**STAFF REVIEW AND RECOMMENDATIONS  
PUBLIC HEARING  
September 21, 2016**

PRELIMINARY PLAT:       **DOERKSEN SUBDIVISION**  
LEGAL DESCRIPTION:       **SEC 15, T18N, R02E, S.M., AK**  
PETITIONER:               **MATTHEW SPECKELS**  
SURVEYOR/ENGINEER:     **PILCH SURVEYING / PIONEER ENGINEERING**  
ACRES:       **5.64**               PARCELS:     **4**  
REVIEWED BY:             **CHERYL SCOTT**               CASE: 2016-108

**REQUEST:**

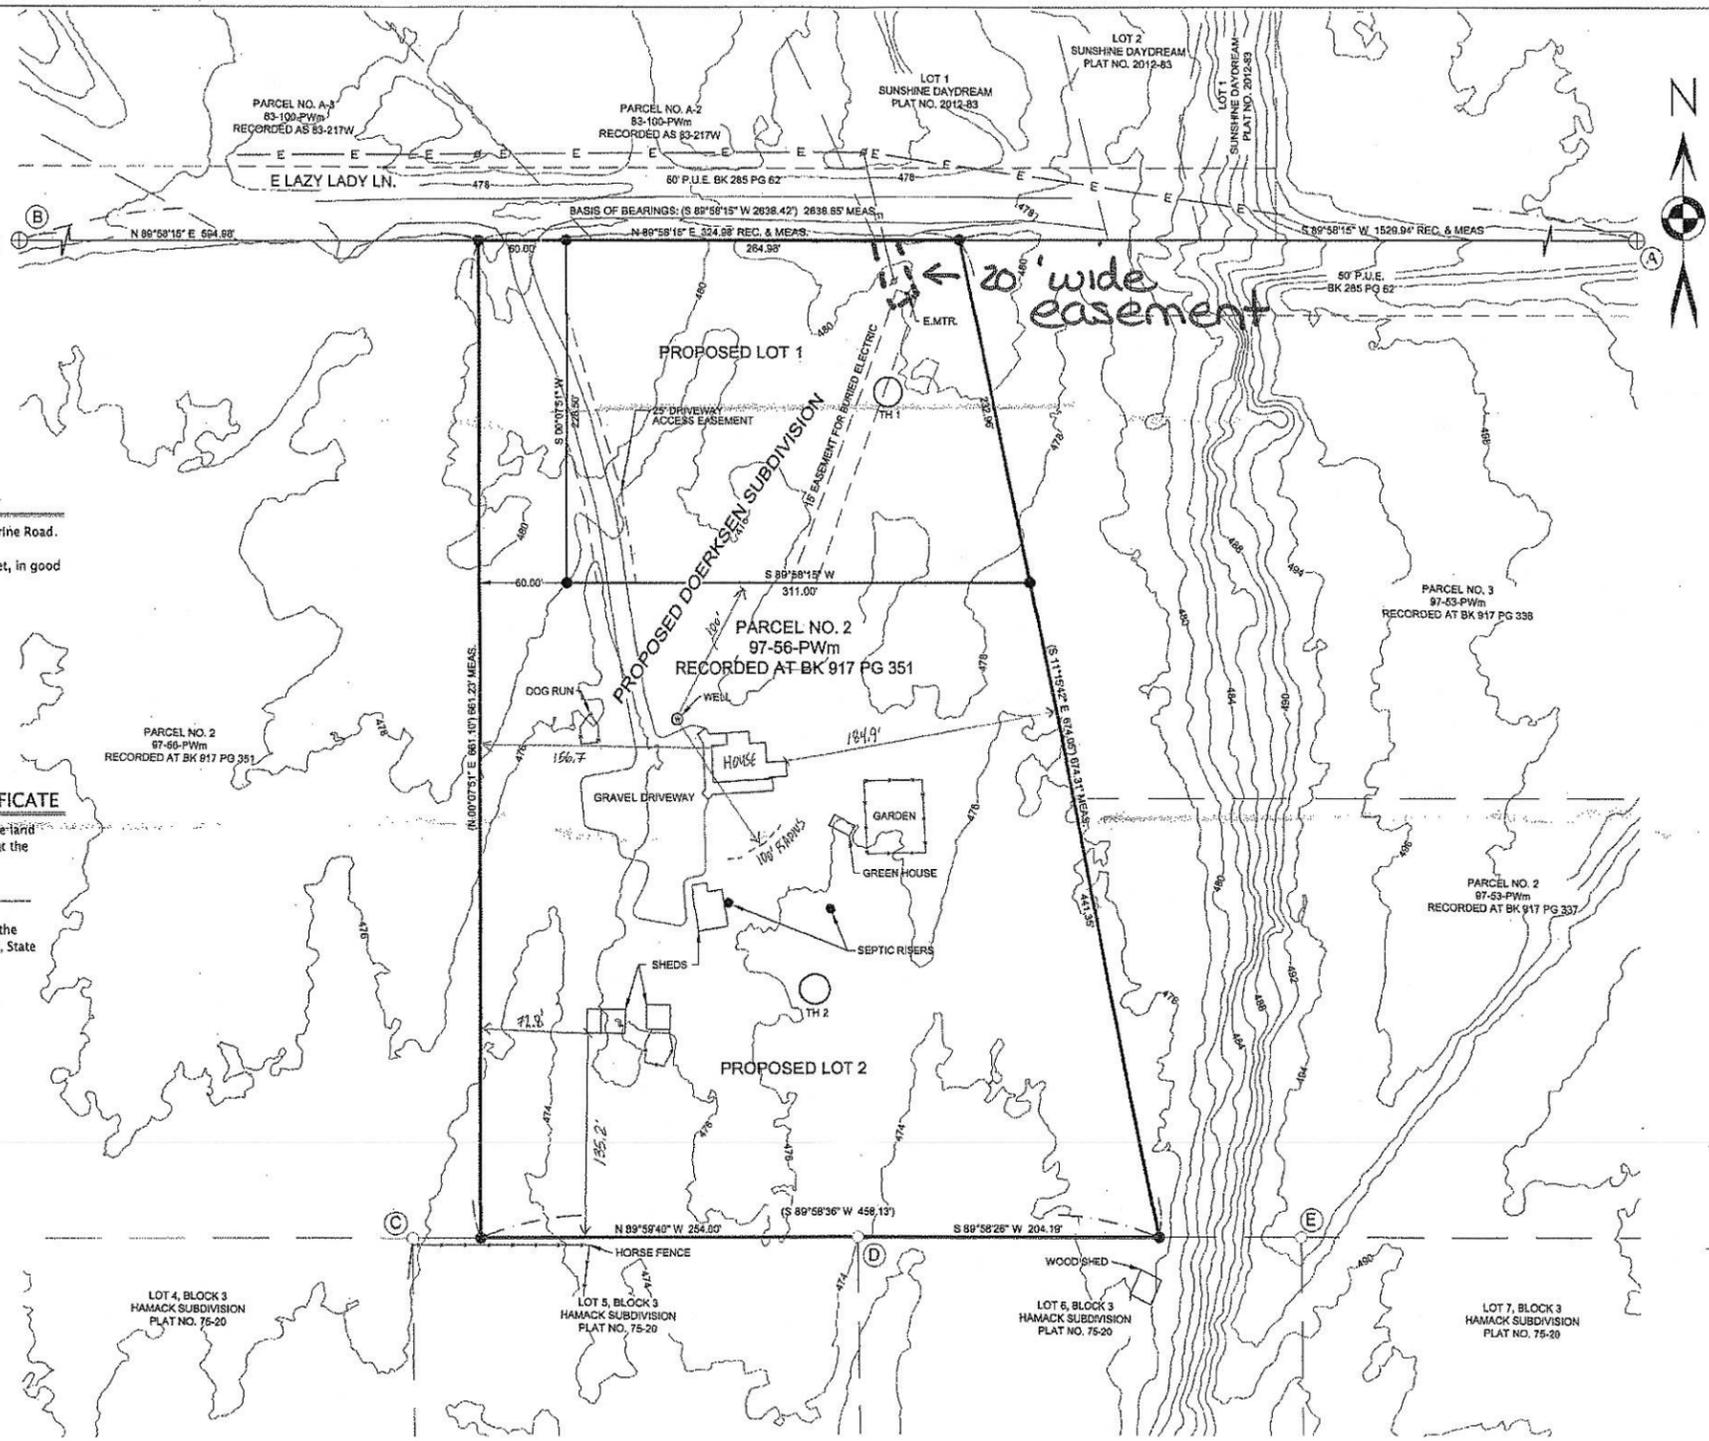
The proposed lots share a driveway and have applied for a driveway permit. The plat shows a 25' private driveway access easement. Staff notes that there is no granting of easements in the abbreviated plat process. The easement will need to be removed before plat recordation or the

MEA is requesting a 20' wide easement to include lift pole & electric meter. (Recommendation 5) **(Exhibit I)**

20' wide utility easement to include lift pole & electric meter

4. Submit an affidavit from any holders of beneficial interest, if any, to be recorded with the plat.
5. Provide utility easement as requested by MEA and show location of easement and recording information on final plat or provide MEA sign off on final plat.

6. Show all easements of record on the final plat per MSB 43.15.051(P).
7. Remove 25' private driveway access easement or add the recording information from the recorded document to the final plat prior to recordation.
